PETITION FOR REVIVAL OF AN APPLICATION FOR PATENT ABANDONED UNINTENTIONALLY UNDER 37 CFR 1.137(b)	Docket Number (Optional) 1644-041
--	---

Title: Seed Treater

**PETITION FOR REVIVAL OF AN APPLICATION FOR PATENT ABANDONED
UNINTENTIONALLY UNDER 35 CFR 1.137(b)
AND
AMENDMENT AND RESPONSE**

RESPONSE TO EXAMINER'S ACTION OF DECEMBER 5, 2001

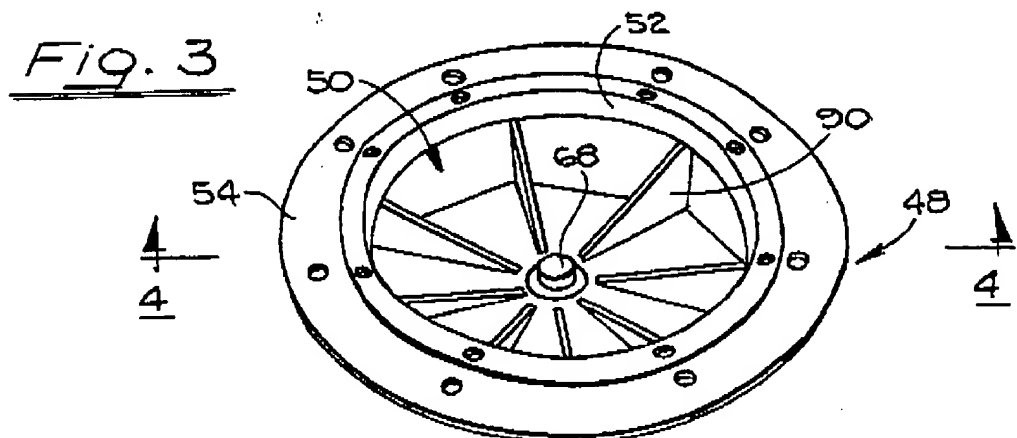
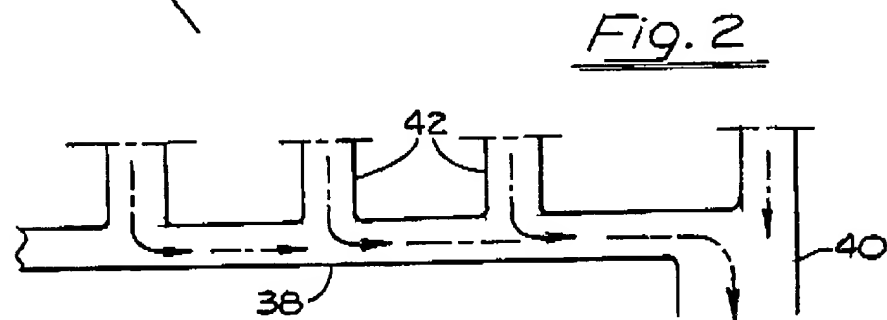
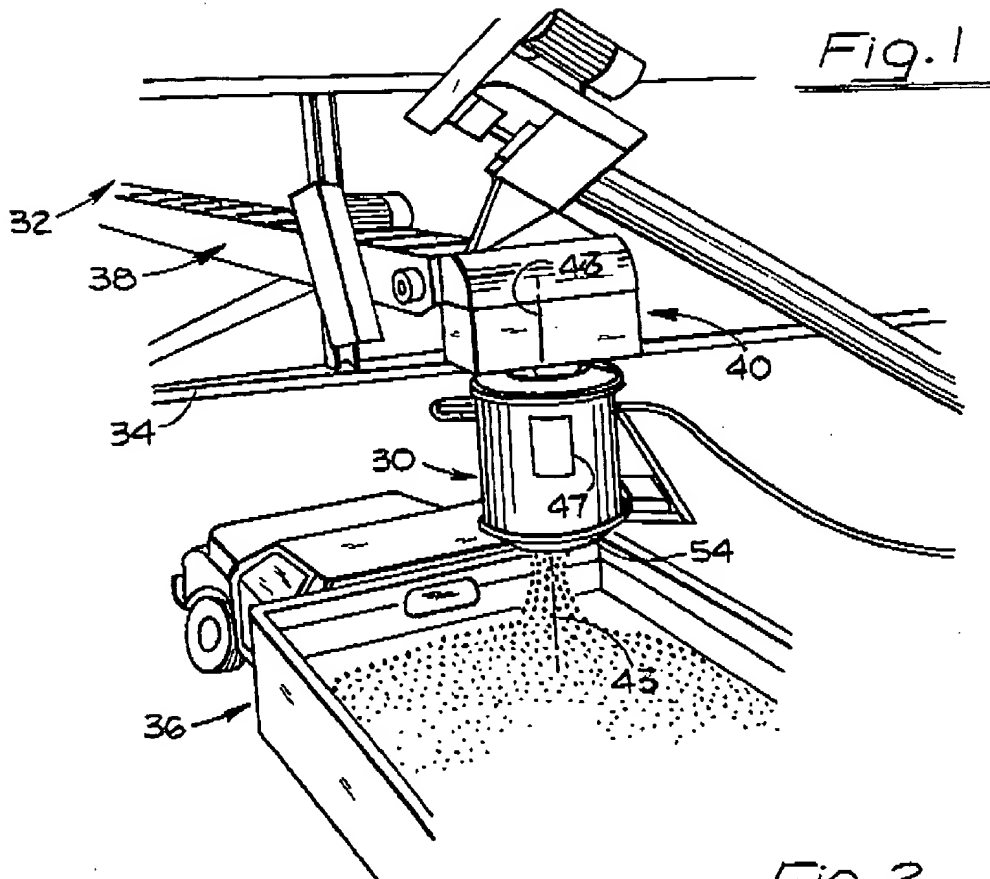
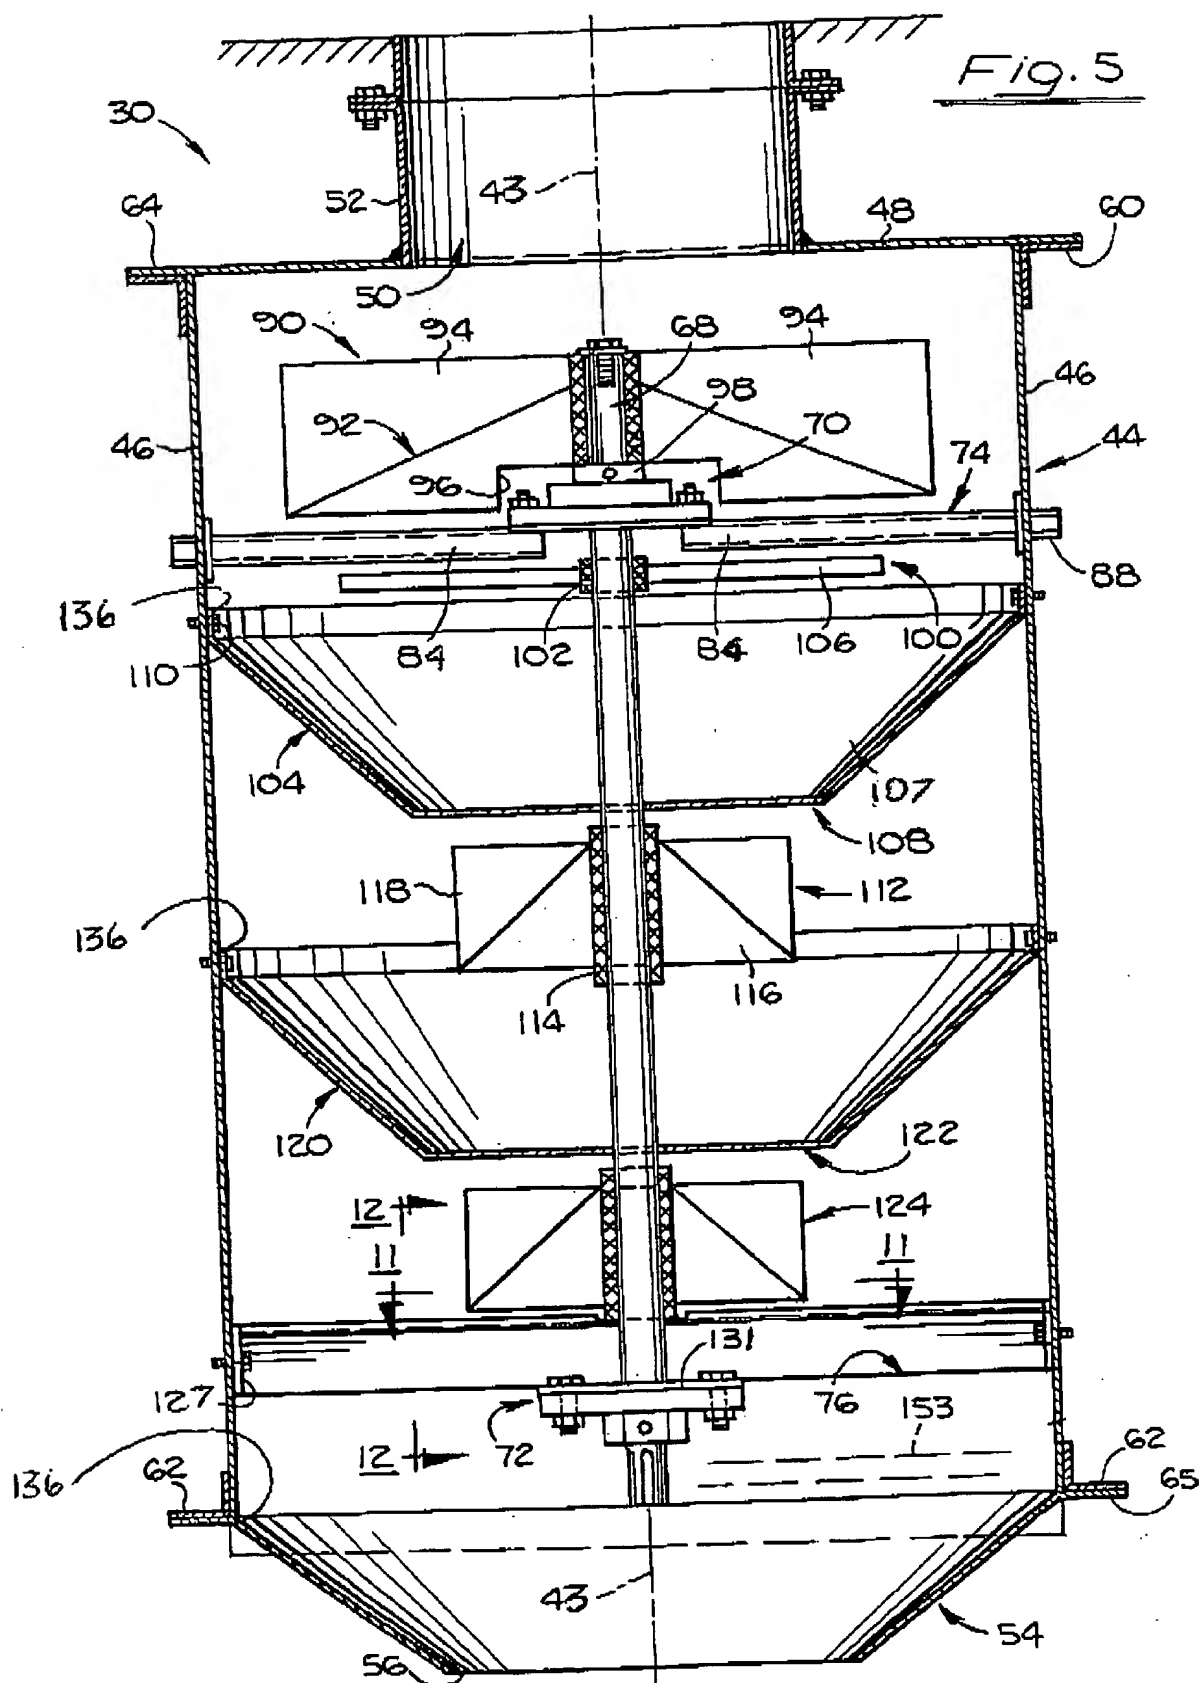
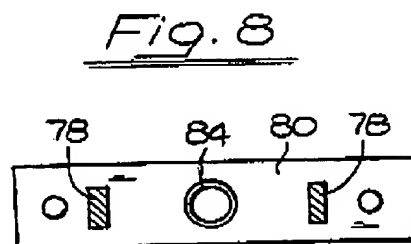
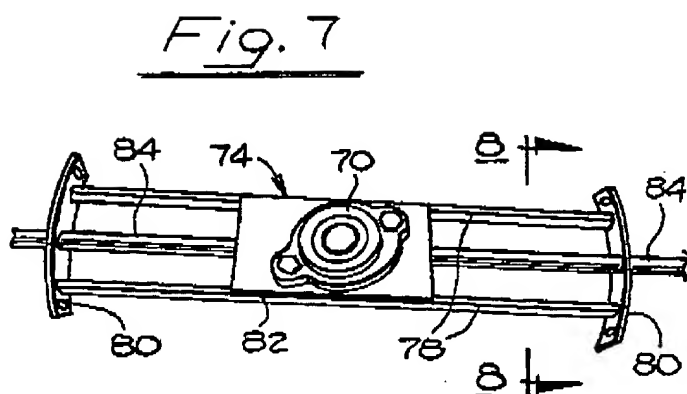
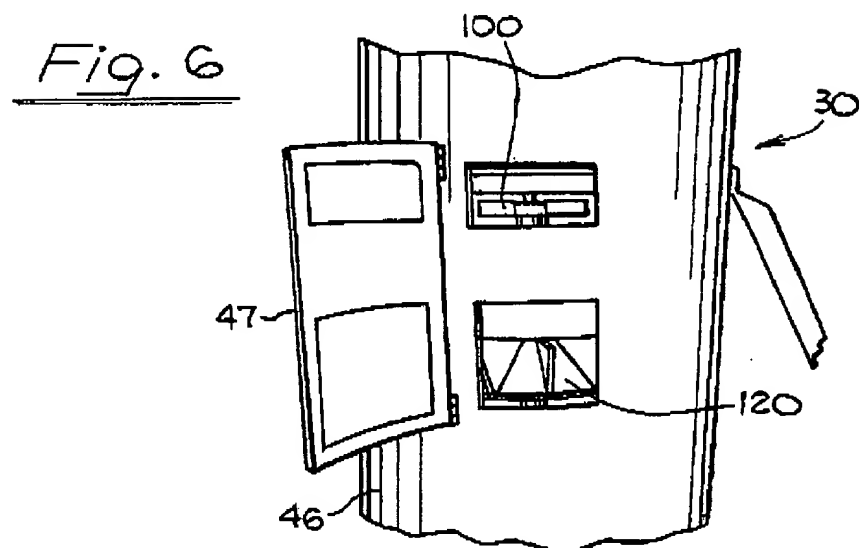
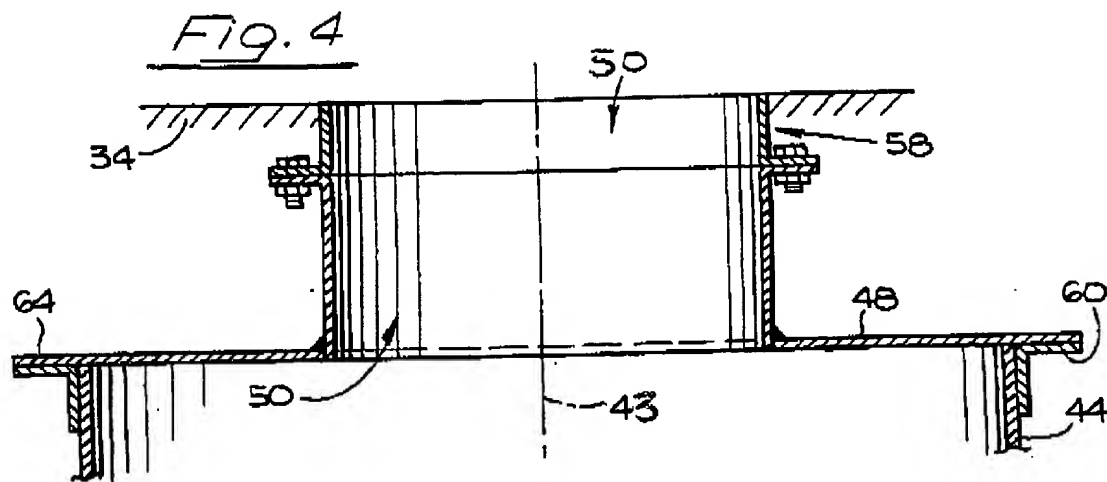
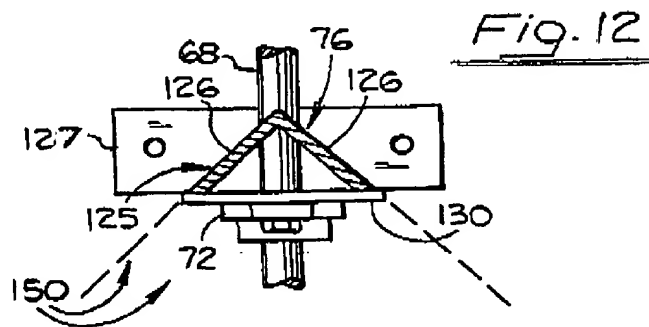
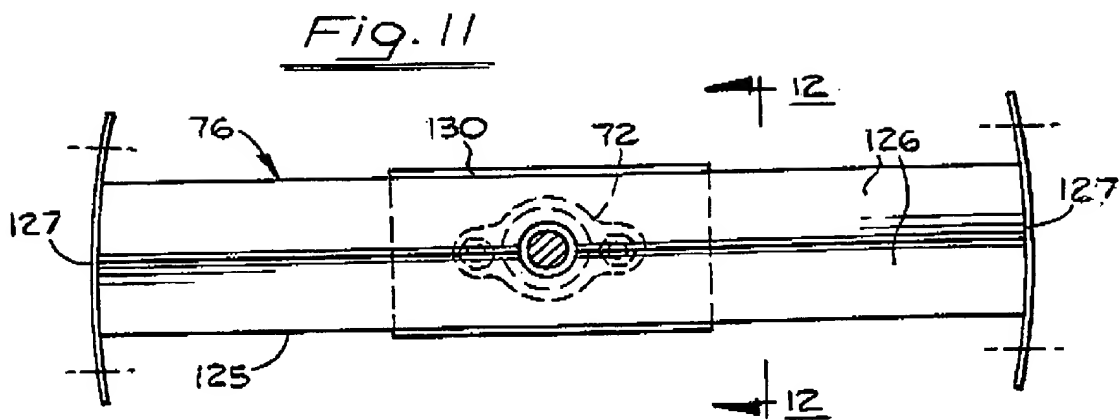
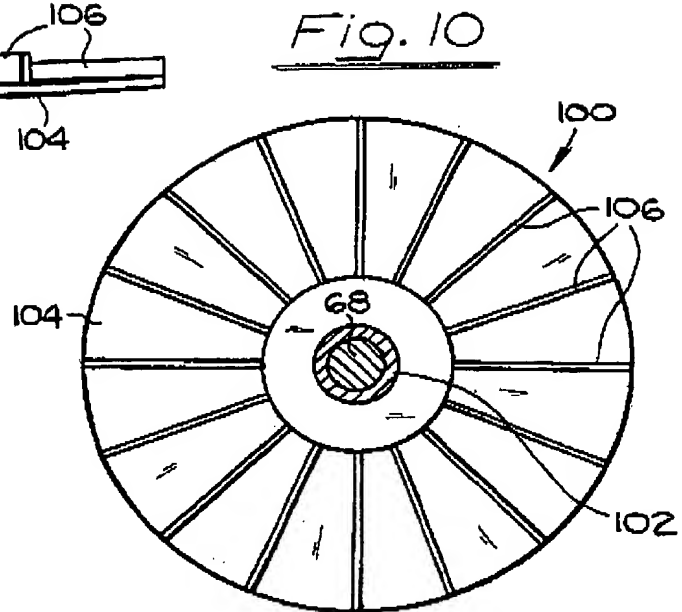
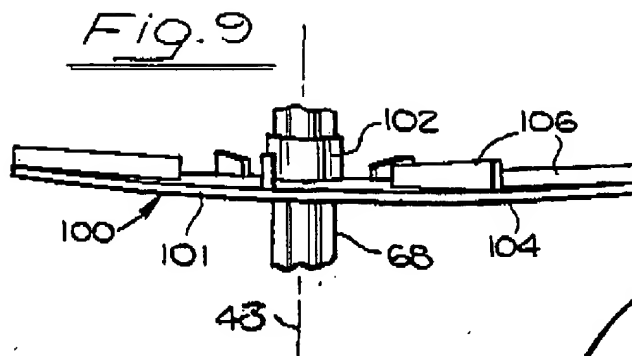
At Page 3, para 6, the Examiner objects to the drawings for failing to comply with 35 CFR 1.84(p)(4) because reference character "44" has been used to designate both the "central axis" and the "stationary drum". The Drawings have been amended to designate the axis as "43" and the specification has been amended accordingly.

At page 3, para 6, the Examiner states that "reference character "60" has been used to designate both the "opening" and "transverse flange" (see fig. 4)". Fig. 4 has been amended to change the "opening" from 60 to 50. Refer to the Specification at page 5/lines 23-24 as follows: "The device has a flat, annular top closure plate 48, with a central inlet opening or feed hole 50, surrounded by a ..."

At page 3, para 6, the Examiner states that "reference character "106" has been used to designate two different items in Fig. 5;" The Specification at page 8/line 4 states "...vertical radial blades 106...". Accordingly, the lower identifier at the bowl (104) with the "106" identifier has been removed from Fig. 5. The "vertical radial blades 106" is seen at Fig, 5, 9 and 10.

At page 3, para 6, the Examiner states that reference character "128" has been used to designate "curved mounting plates" in Figs. 5, 11 and 12 and a "wiper" in Fig. 14;" Wiper 128 is illustrated in Fig. 14 and referenced in the specification at pages 11 and 12. Curved mounting plate 128 is illustrated in Fig. 5, 11 and 12 and referenced at the specification page 10. The Drawings have been amended at Fig. 5, 11, and 12 to change the curved mounting plate from designation 128 to 127 and the specification at page 10/lines 1-6 and lines 18-22 and lines 23-24 have been amended from 128 to 127.

1 used to designate "a central plate" in Figs. 5, 11 and 12 and a "wiper" in Fig. 14;" The
2 Drawing has been amended at Fig. 5 to change the central plate from designation 130 to
3 131 and the specification at page 10/lines 1-6 has been amended from 130 to 131.

4 At page 3, para 6, the Examiner states that "Reference character "132" has been
5 used to designate "a small flat steel mounting piece" in Figs 14 and an unknown item in
6 Fig. 5;" Fig. 5 illustrates the hogback (76) which is an inverted "V" shaped structure.
7 The designator "132" has been removed from Fig. 5.

12 At page 3, para 6, the Examiner states that "Also, reference character "46" appears
13 to be used to designate the central axis in Fig. 4, whereas "46" designates a wall
14 according to the specification and other figures." The Examiner is referred to the initial
15 reference character "44" objection at page 3 which the Examiner indicated to designate
16 the "central axis". Please note that the reference in Fig. 4 was changed to "43".

7 At page 4 the Examiner notes that "imperforate wall 107" (see page 8, line 17) is
8 not shown. The specification page 8/lines 16-17 demonstrate that the "imperforate wall
9 107" is to be found at Fig. 5 and the Examiner will find "107" added at the bowl structure
10 104.

5 Drawing Fig. 5, at reference character 74 illustrates exterior fitting (88), as
6 disclosed in the Specification at page 7 and addressed in Response to page 6/paragraph 26
7 of these Examiner rejections. Fig. 5, as submitted, disclosed reference character 86 to the
8 structure connection to 88.

9 Fig. 5 has been amended to change 86 to 84.

Fig. 13

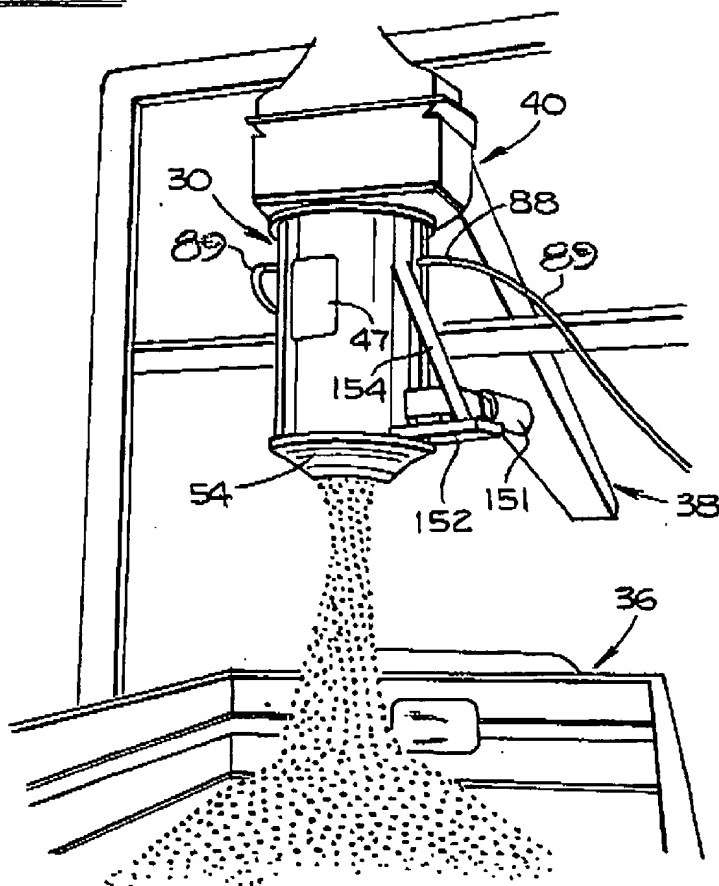
8 At page 3, para 6, the Examiner states that "Reference character "142" has been
9 used to designate two different items in Fig. 14 as well as two other items in Fig. 13."
10 The Drawing Fig. 13 has been amended to show "89" in-place of "142" as supported by
11 the Specification at page 14/lines 12-14.
